Mayberry Filing No. 3
Traffic Technical Memorandum
(LSC #S224210)
May 19, 2022

Please add PCD¹
File No. SF2219

Figure 1

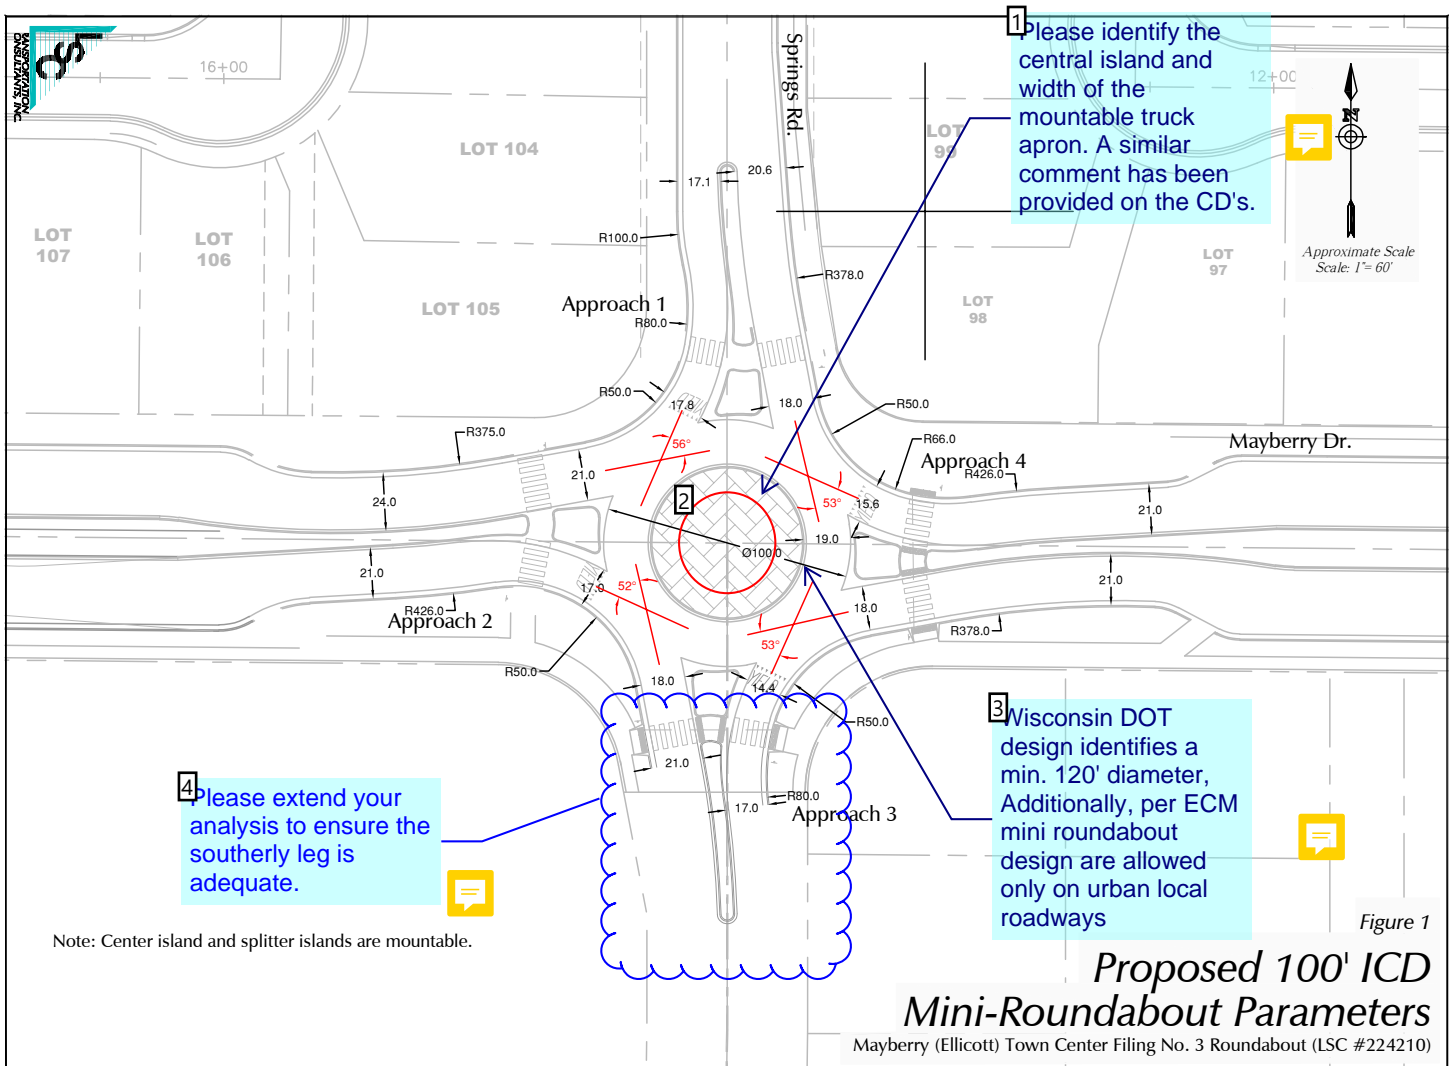
Please identify the central island and width of the mountable truck apron. A similar comment has been provided on the CD's.

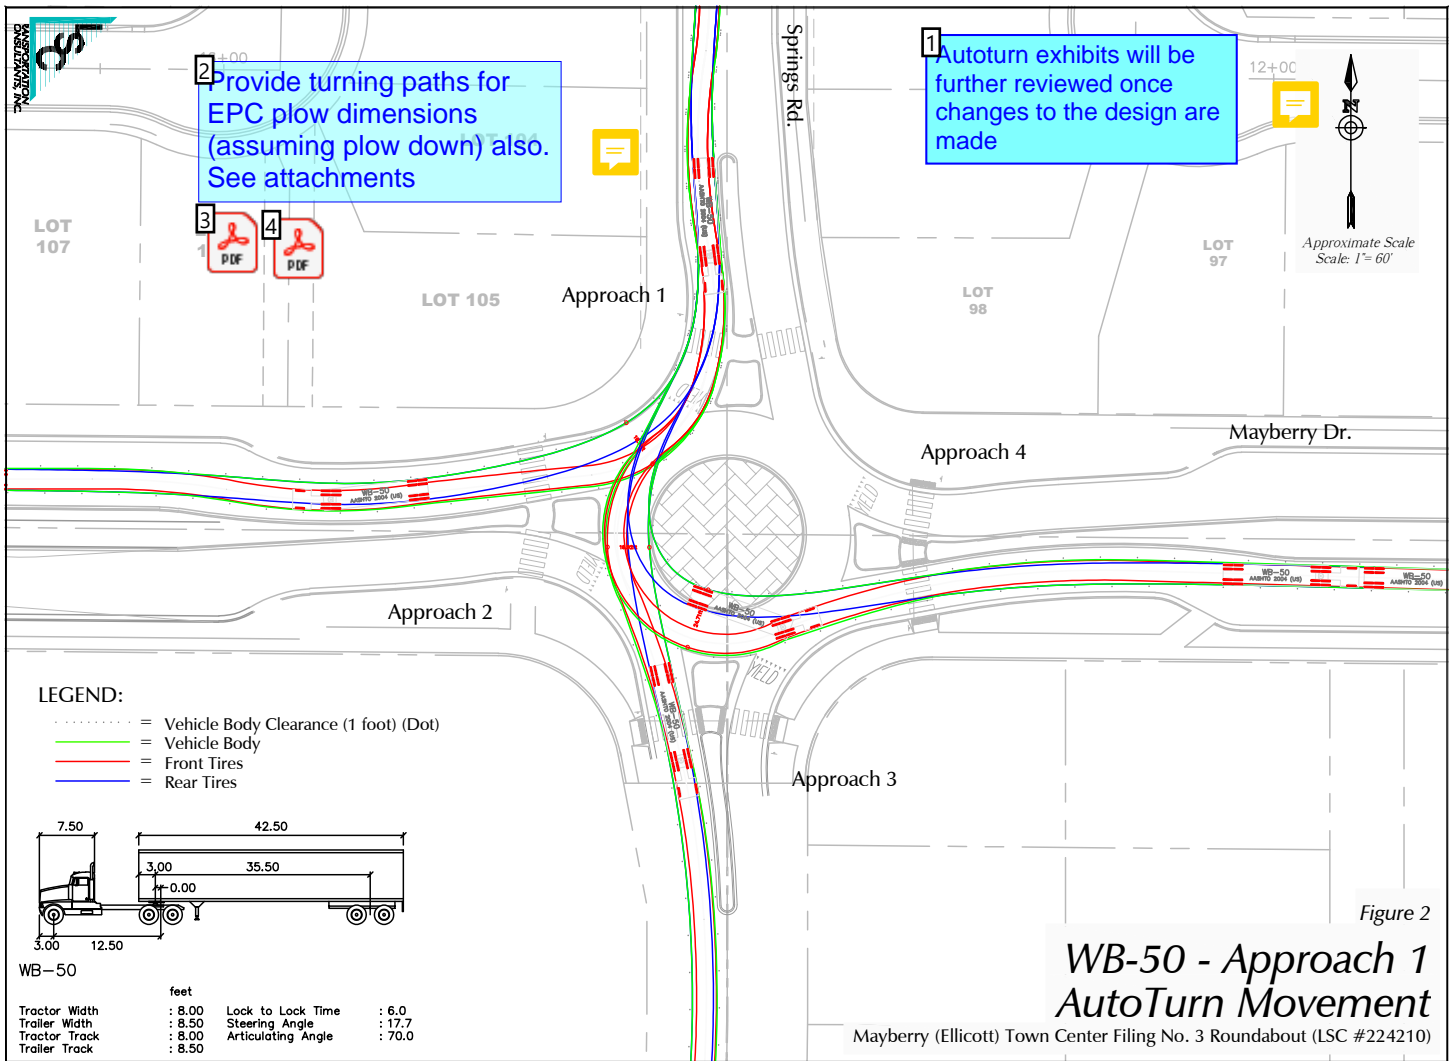
Wisconsin DOT design identifies a min. 120' diameter, Additionally, per ECM mini roundabout design are allowed only on urban local roadways

Please extend your analysis to ensure the southerly leg is adequate.

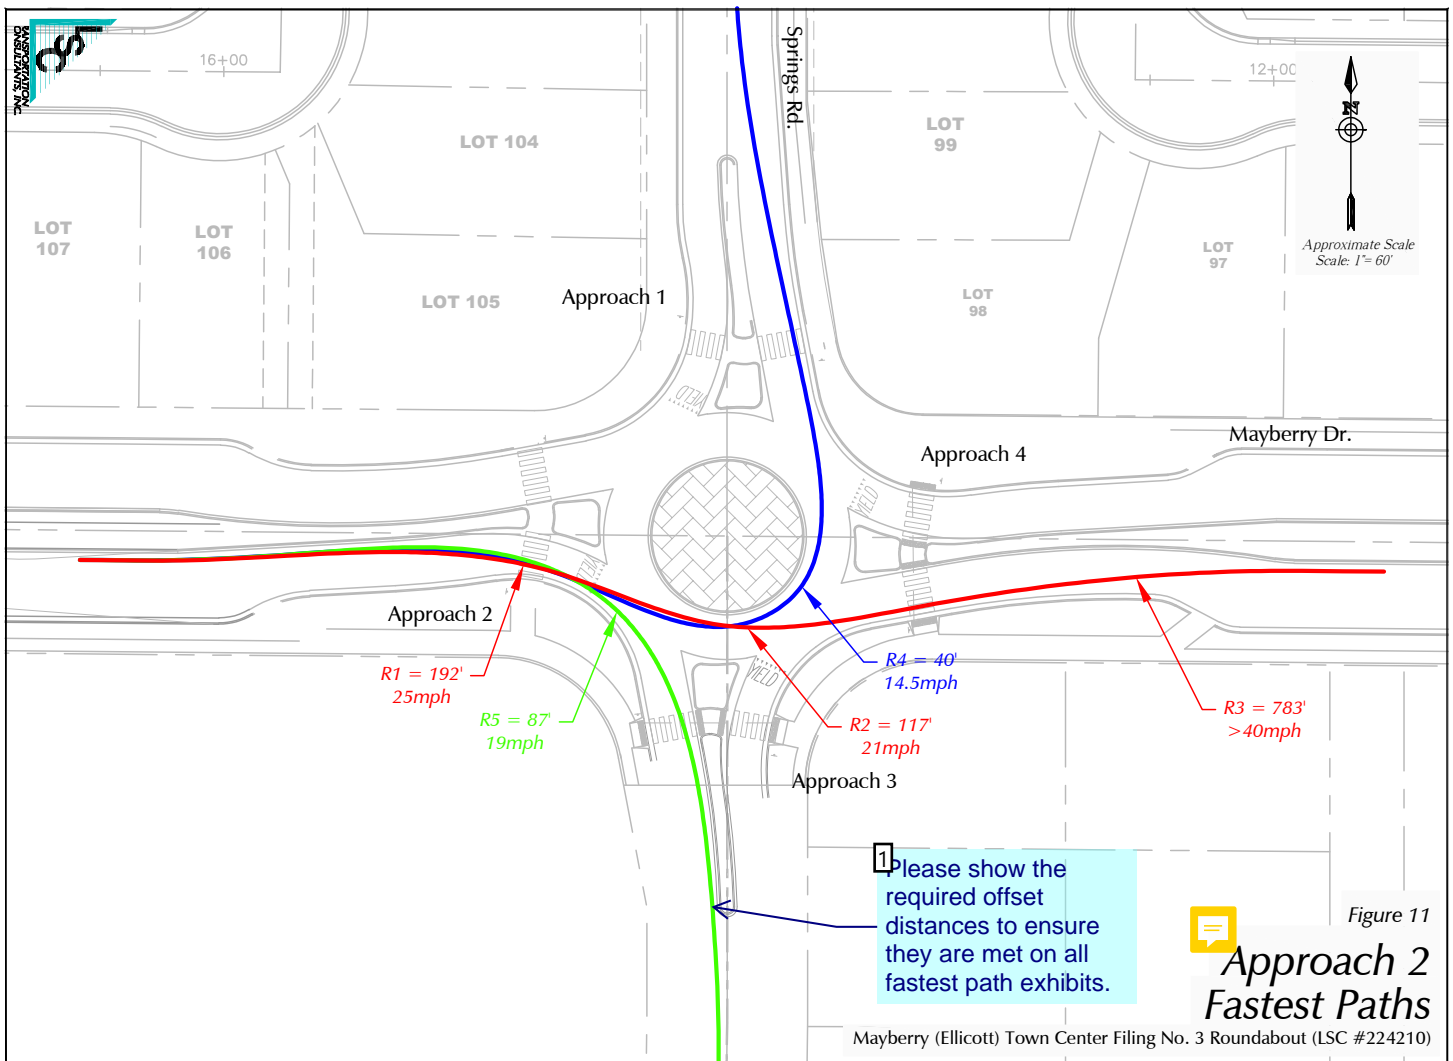
[Autoturn exhibits will be further reviewed once changes to the design are made](#)

[Provide turning paths for EPC plow dimensions \(assuming plow down\) also. See attachments](#)

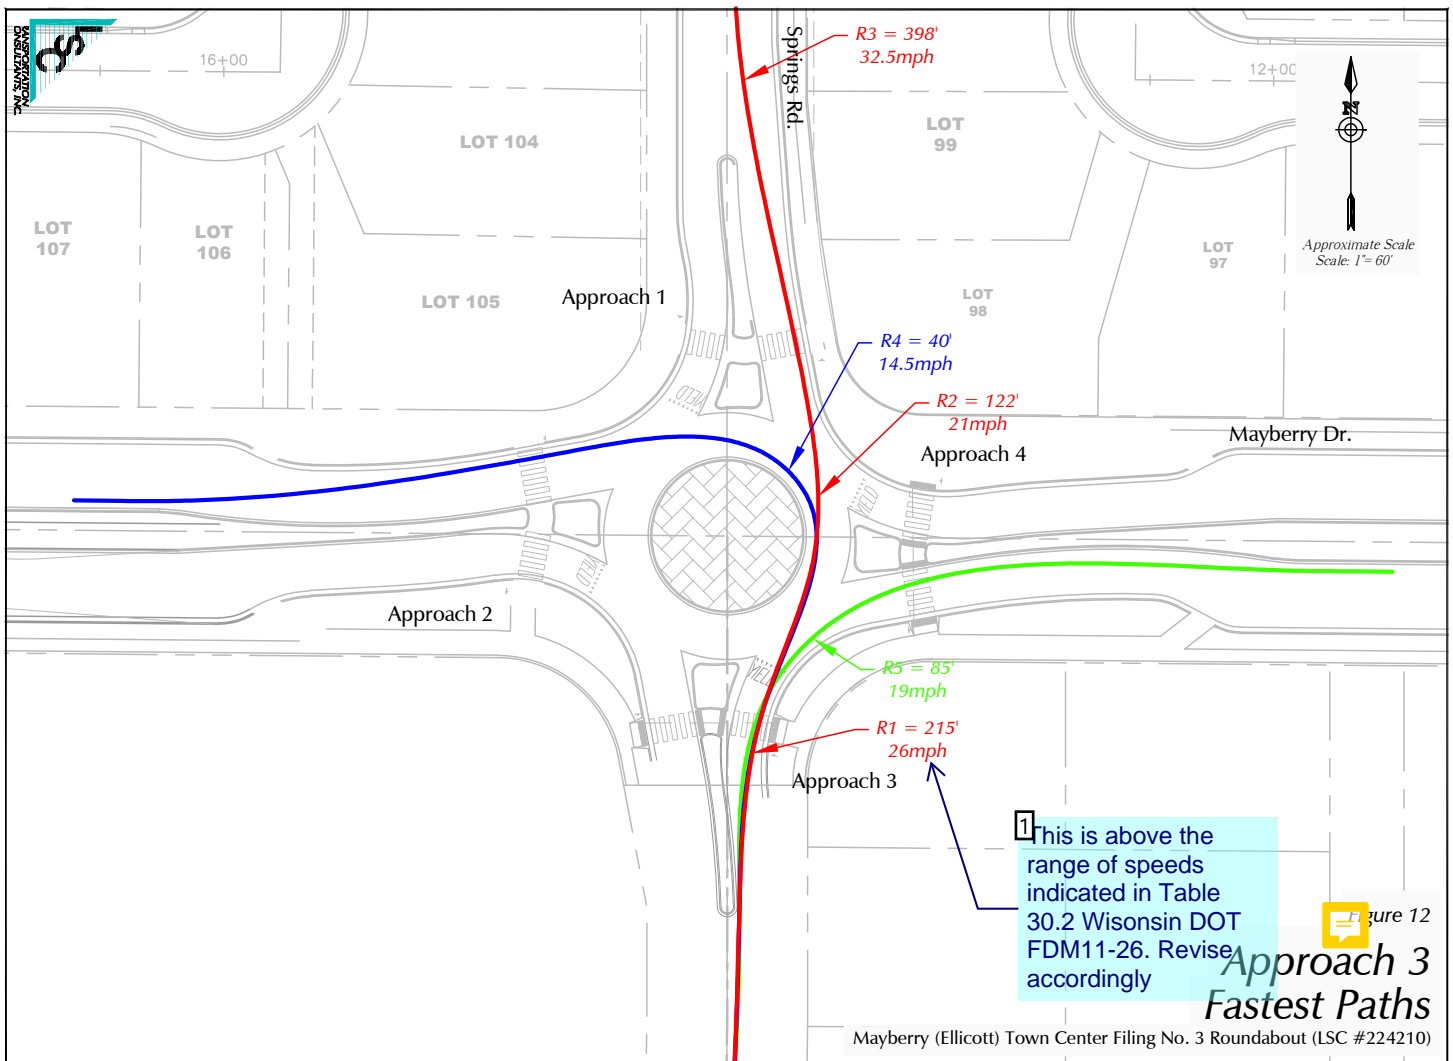
Please show the required offset distances to ensure they are met on all fastest path exhibits.

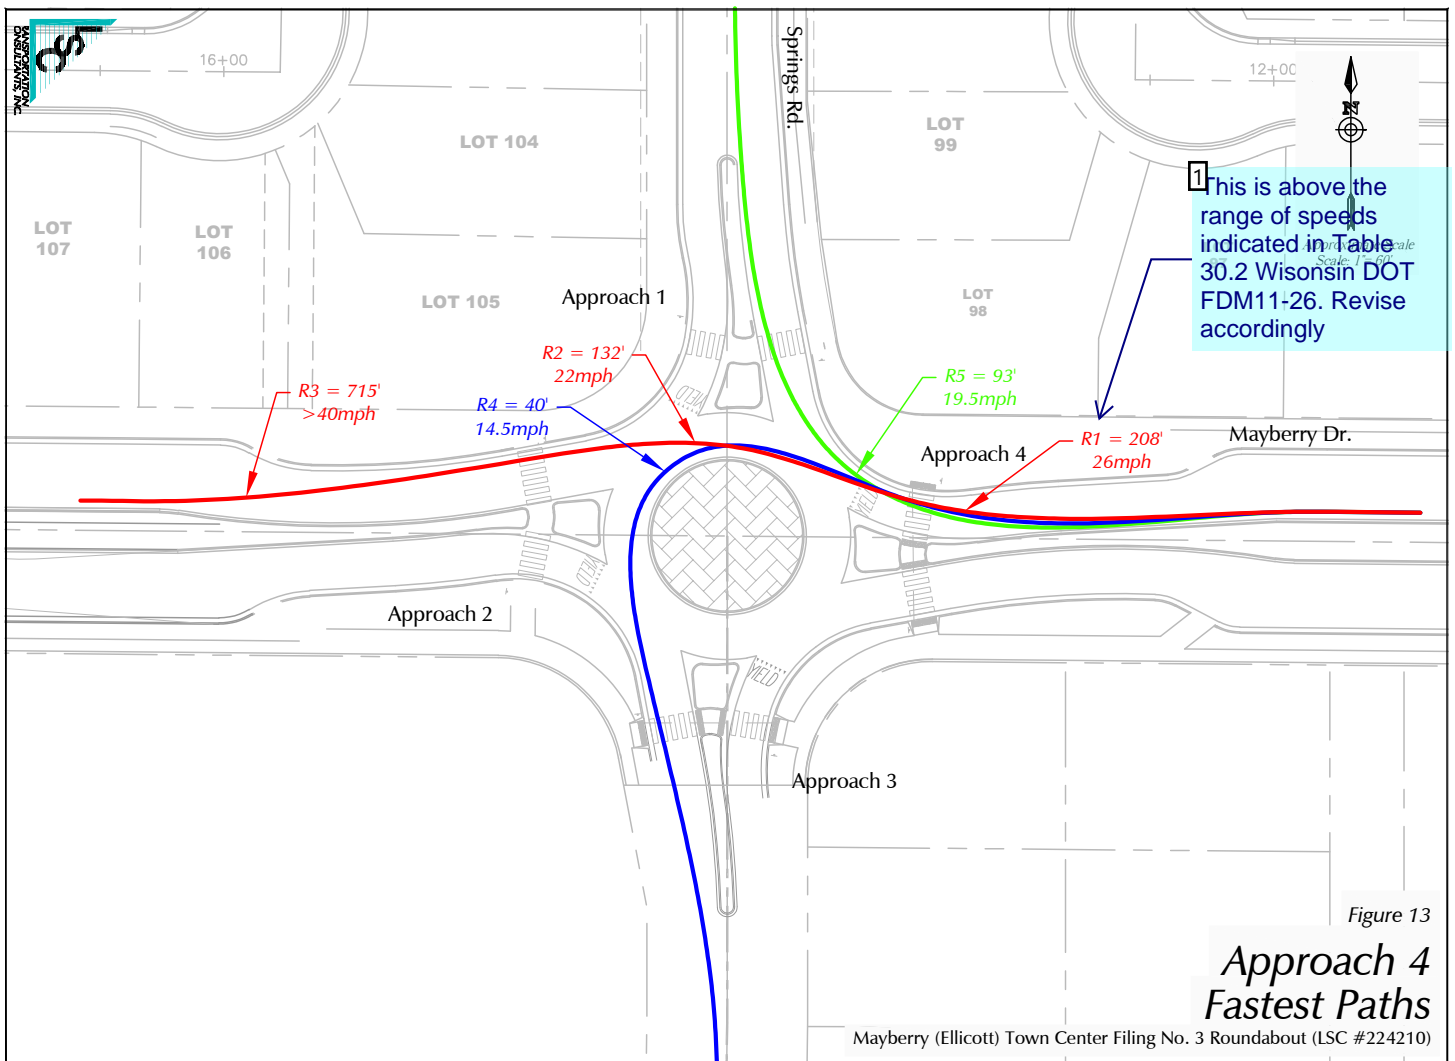
This is above the range of speeds indicated in Table 30.2 Wisconsin DOT FDM11-26. Revise accordingly

This is above the range of speeds indicated in Table 30.2 Wisconsin DOT FDM11-26. Revise accordingly
